35/13-03Y 16 Newland's Street
Chevy Chase Village Historic District

SUBJECT: Historic Area Work Permit # 324579

The Montgomery County Historic Preservation Commission (HPC) has reviewed the attached application for a Historic Area Work Permit (HAWP). This application was **APPROVED WITH THE FOLLOWING CONDITIONS.**

Address:	16 Newlands Street	Meeting Date:	1/28/04
Resource:	Contributing Resource Chevy Chase Village Historic District	Report Date:	1/21/04
Review:	Revised HAWP	Public Notice:	11/14/03
Case Number:	35/13-03Y	Tax Credit:	No
Applicant:	Dr. Robert and Susan Morgenstein	Staff:	Joey Lampl

VIEW FROM REAR YARD

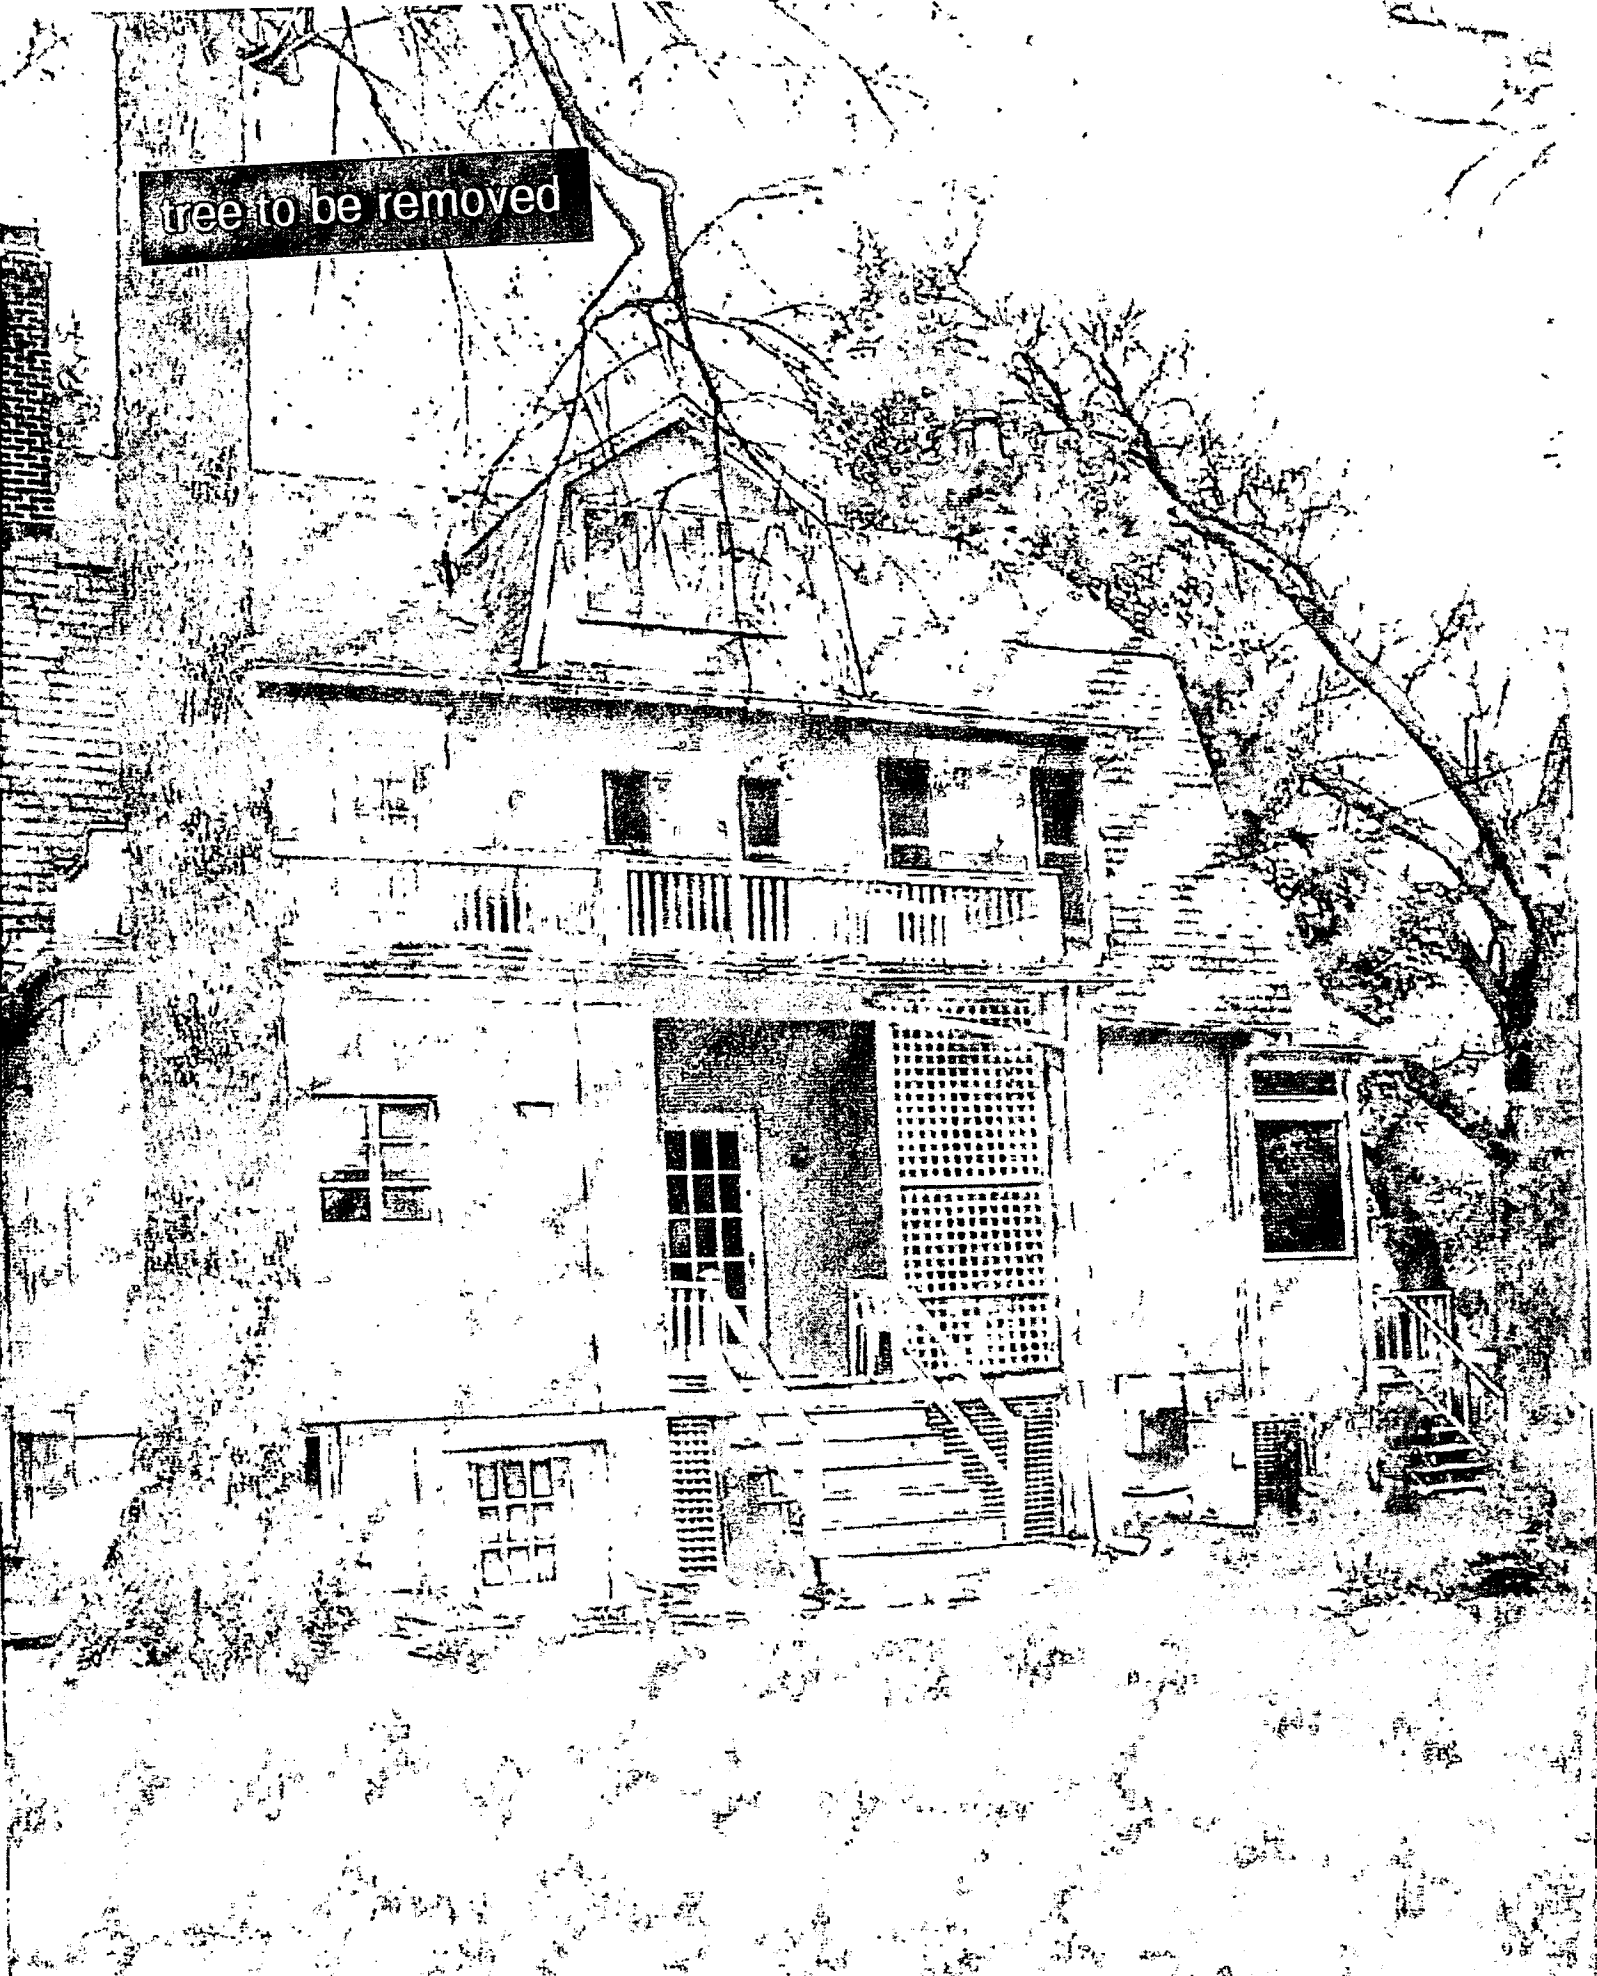
2. Remove an 8-10 inch diameter tree at the southwest corner of the existing house in order to extend the footprint to the rear. The applicants plan to submit a Tree Removal Application with the Chevy Chase arborist. (See Circle 17.)

Staff has been told that the owners will proceed with a Tree Removal Application from the Chevy Chase Village arborist for the one maple tree that is currently near the southwest corner of the house. Since the *Chevy Chase Village Historic District – Expansion Guidelines* recommend "strict scrutiny" for the removal of trees, staff advises that the owner obtain approval for the tree removal (and any necessary reforestation beyond the planting of the three new trees) prior to carrying out any new construction.

tree to be removed

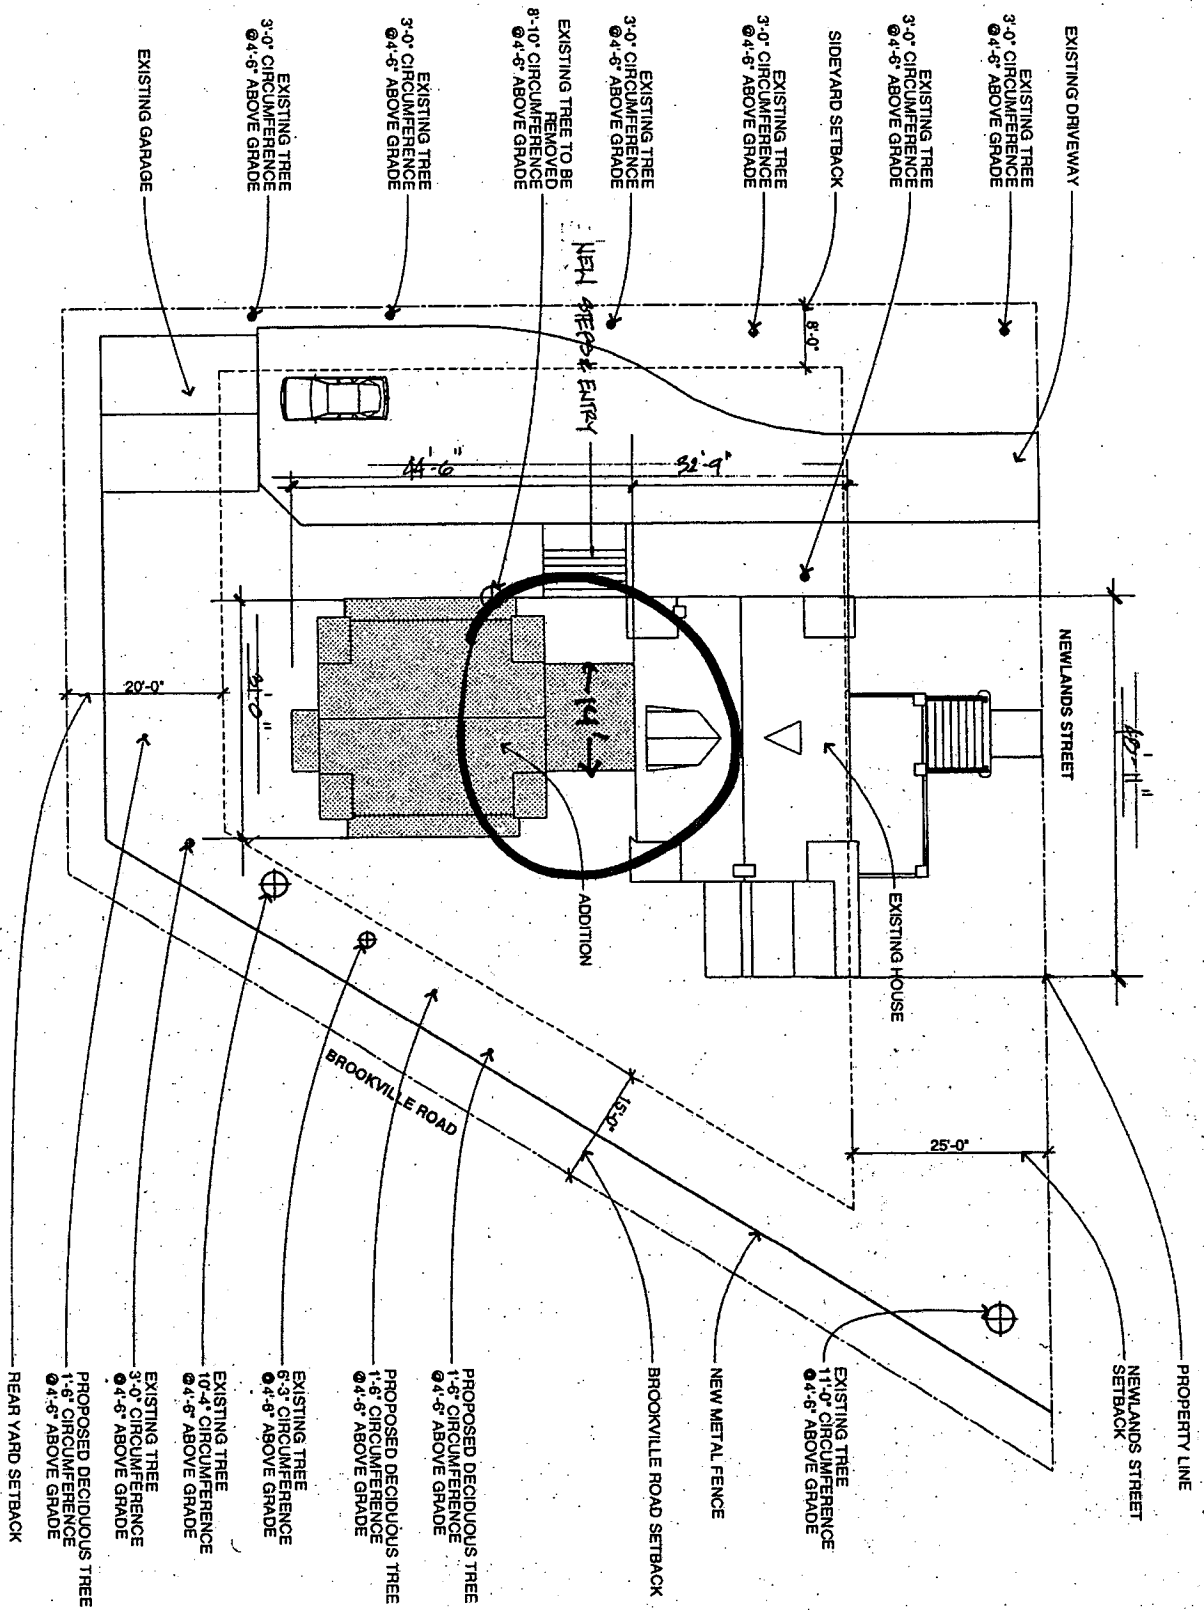
replacing with 3 trees - 2 along Brookville

1 at south end of lot...

VIEW FROM REAR YARD

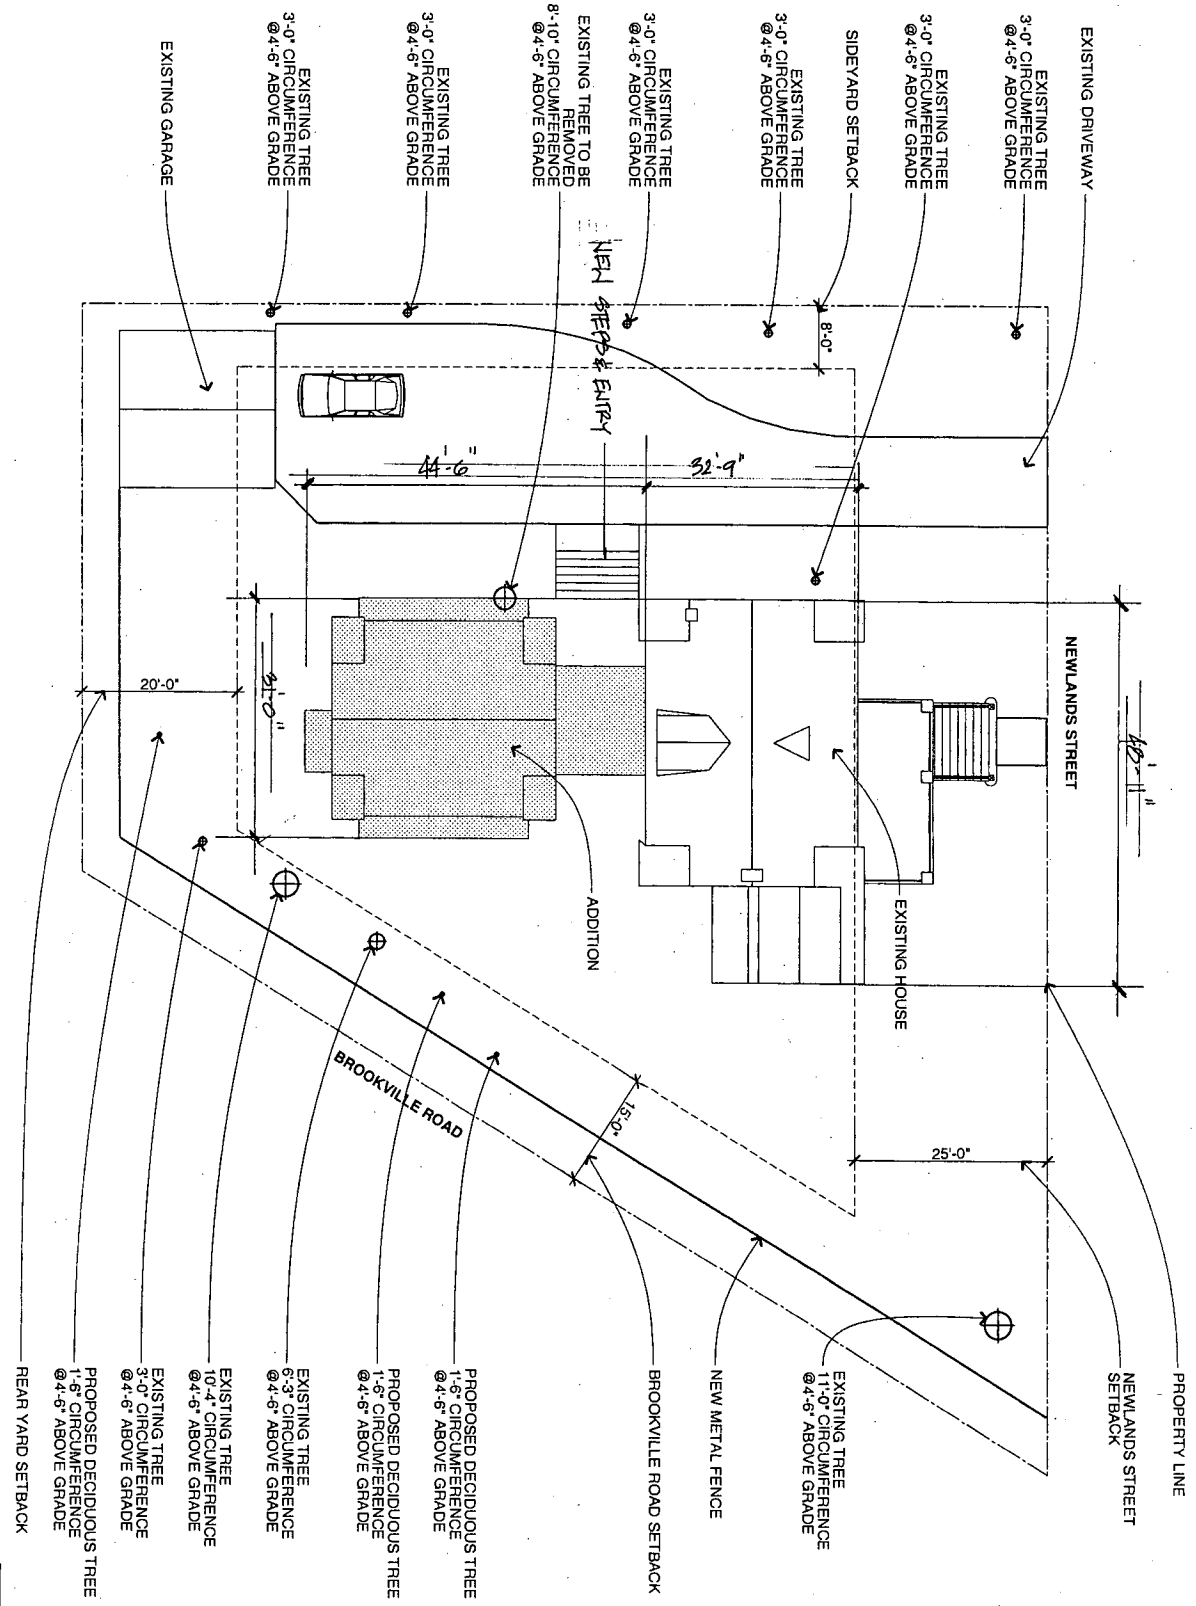
tree to be removed

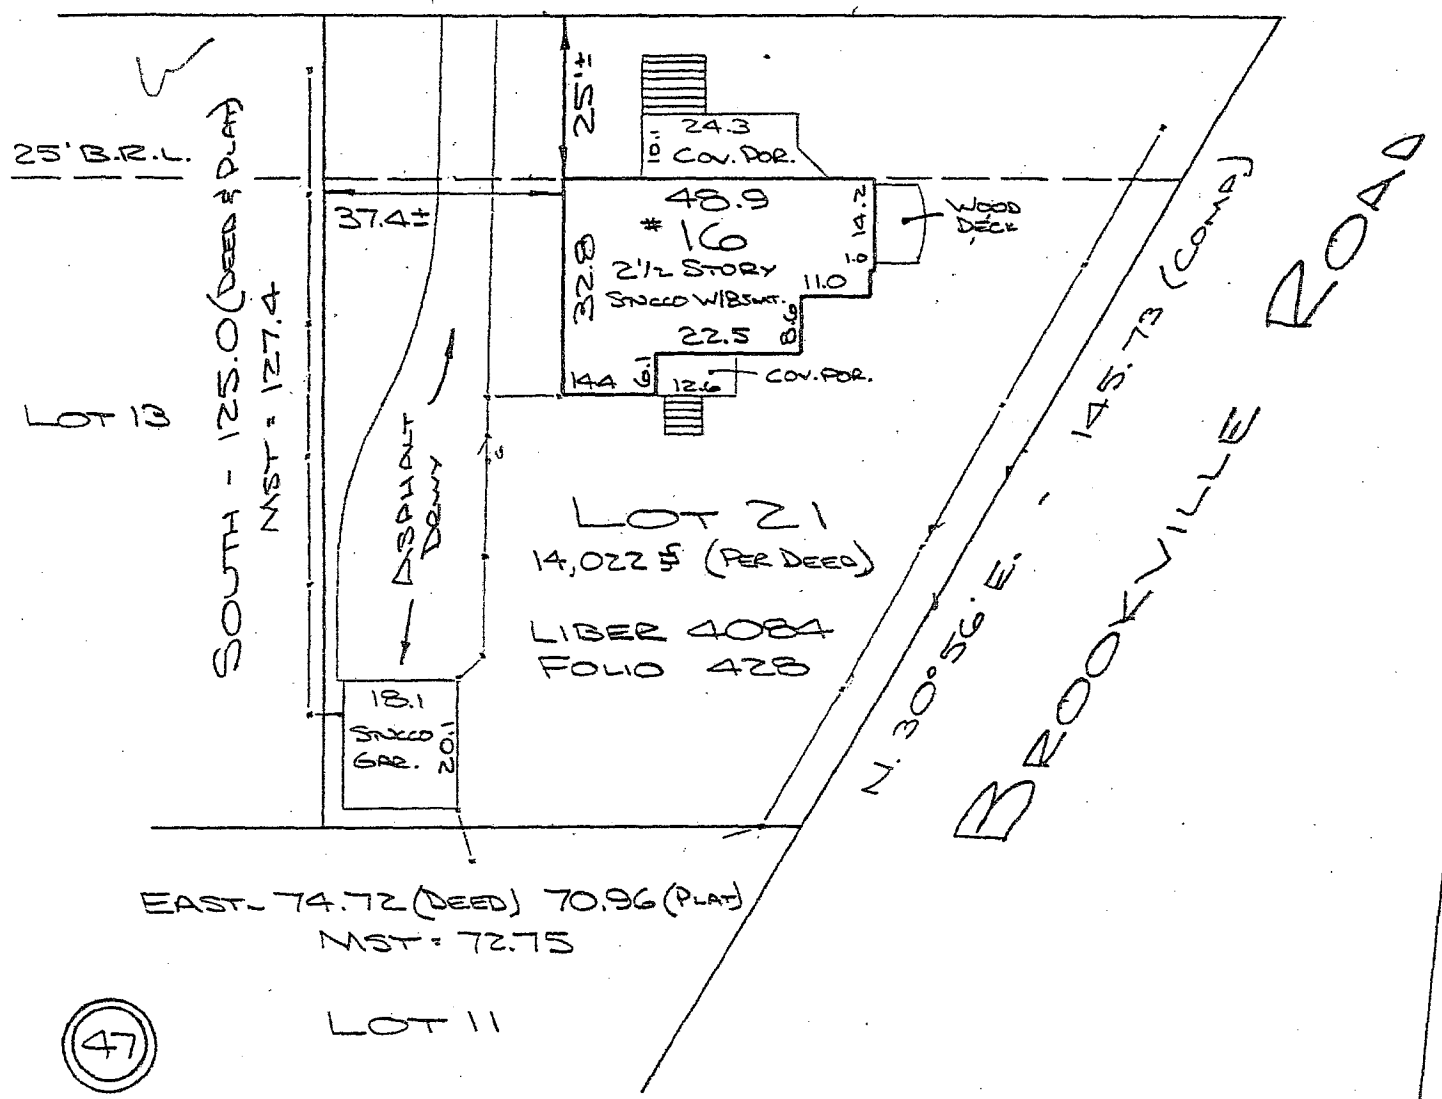
adamant that she can get variants
most - original covenant -
specifically 25' from Brookville -
no variance - no language -
can get variance
land records - tomorrow
